Rezoning Transportation Analysis

Petition Number: 2026-023

Date	Description
04-23-26	First Review (CM)

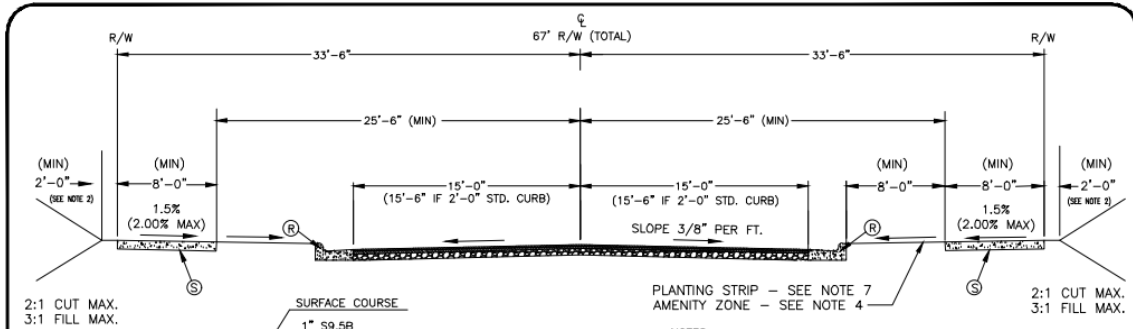
- a. **Wilkinson Boulevard:** Location of future back of curb and gutter needs to be minimum 33 feet from centerline of roadway.

4+ Boulevard, Shared Use Path from Streets Map

Label and dimension the curb and gutter from the centerline for each road on the site plan.

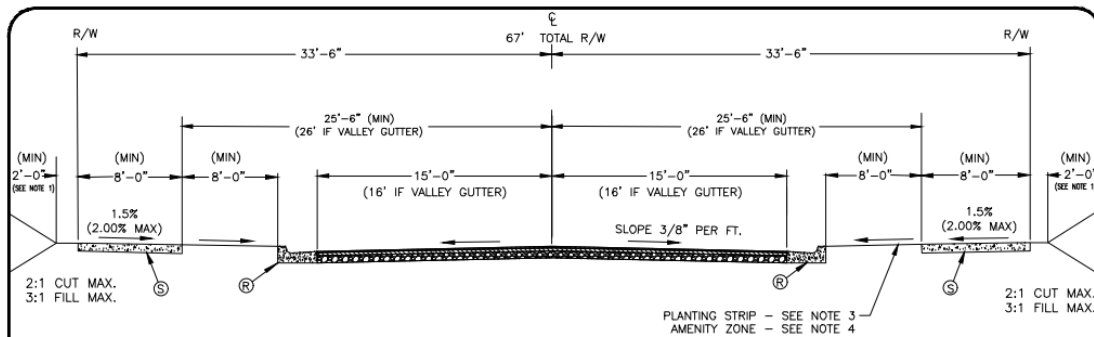
- b. **Internal Public Local Roads:** Location of future back of curb and gutter to be constructed minimum 17.5ft from centerline of roadway.

Label and dimension the curb and gutter from the centerline for each road on the site plan.

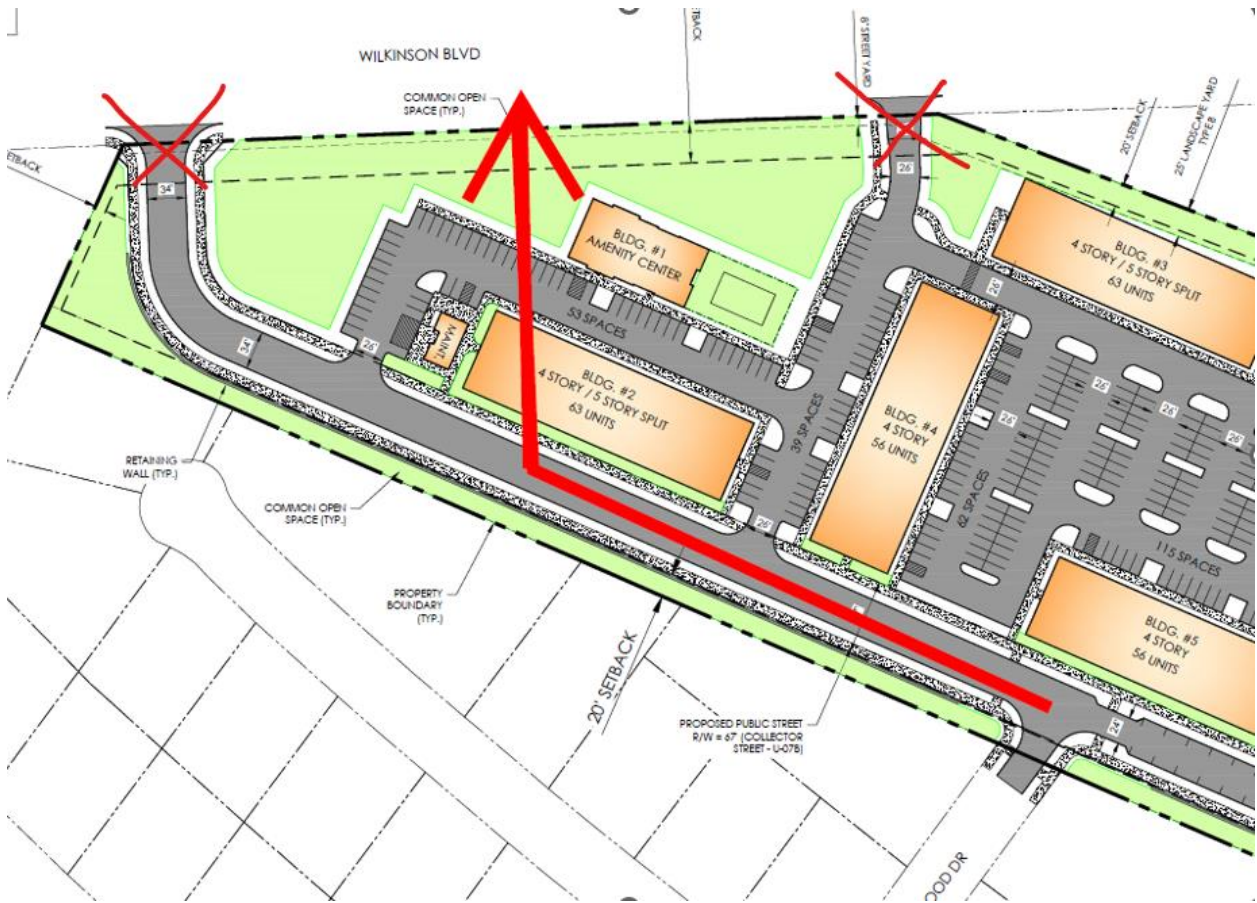
The petition's zoning falls within the low intensity development which based on the 2,409 daily trips will trigger Tier 3 (9 mitigation points) for multimodal assessment. The petitioner shall review and assess the publicly accessible pedestrian network within ¼ mile walking distance of the site to identify multimodal infrastructure to meet the Tier 3 (9 mitigation points) for multimodal assessment.

Complete CTR summary table and include it on the revised plan. CTR table link (use Site Data Table – CTR Summary tab): <https://www.charlottenc.gov/files/sharedassets/city/v/2/growth-and-development/documents/dev-center-fees/resources/udo-site-data-tables-curb-ramps-and-ctr.xlsx>
